Bulletin No.: L03-007
Release Date: 8/31/06
Effective Date: Immediately
Supercedes: N/A
Completion Date:
Sept. 15, 2006

SERVICE BULLETIN

**Ride Name: HI-ROLLER PORTABLE MODELS AND
CRAZY TRAIN PORTABLE MODELS**

Mandatory Bolt, Nut, and Washer replacement schedule for track sections

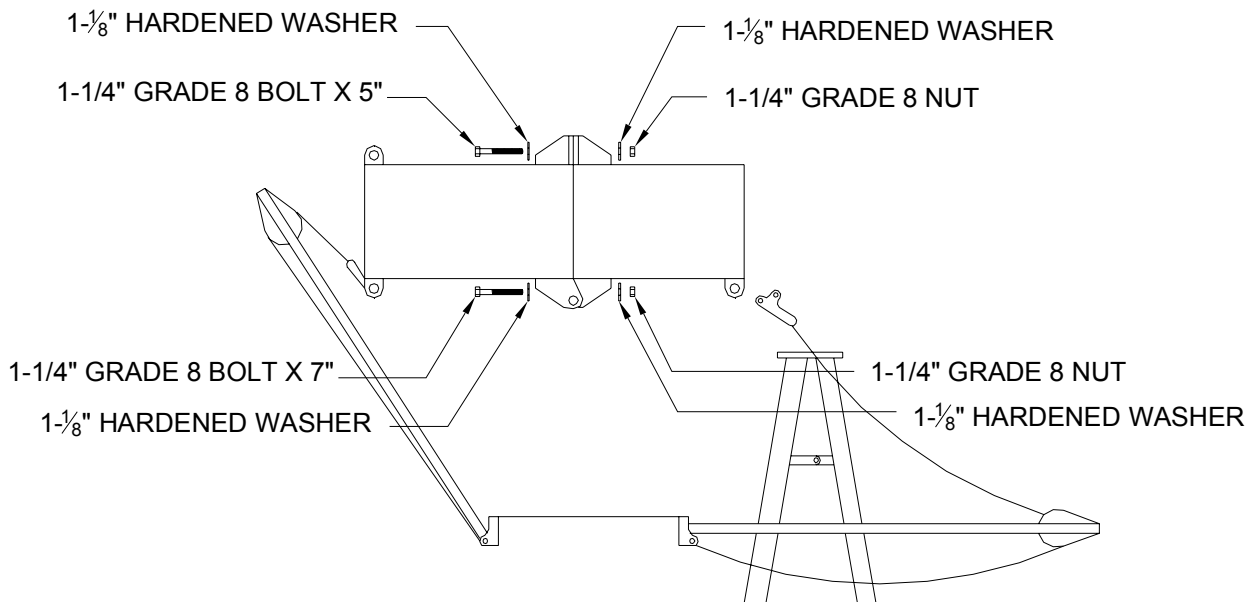
Larson International Inc. has learned that the Grade 8 bolts, Grade 8 nuts, and hardened washers being used to fasten the two track sections together on the Crazy Train and Hi-Roller rides are being replaced with substandard bolts, nuts, and washers. There is reasonable concern that serious personal injury and property damage could result from failure of these fasteners.

1. Remove all ten, 1-1/4" bolts, nuts, and washers currently being used to fasten the two track sections together.
2. Replace with 1-1/4" Grade 8 UNC bolts, Grade 8 UNC nuts, and 1-1/8" hardened washers purchased from Larson International, Inc.

3. All bolts and nuts must be dry torqued to 400 foot pounds with a torque wrench.
4. Proper bolt tension must be checked daily with a torque wrench to 400 foot pounds of torque.
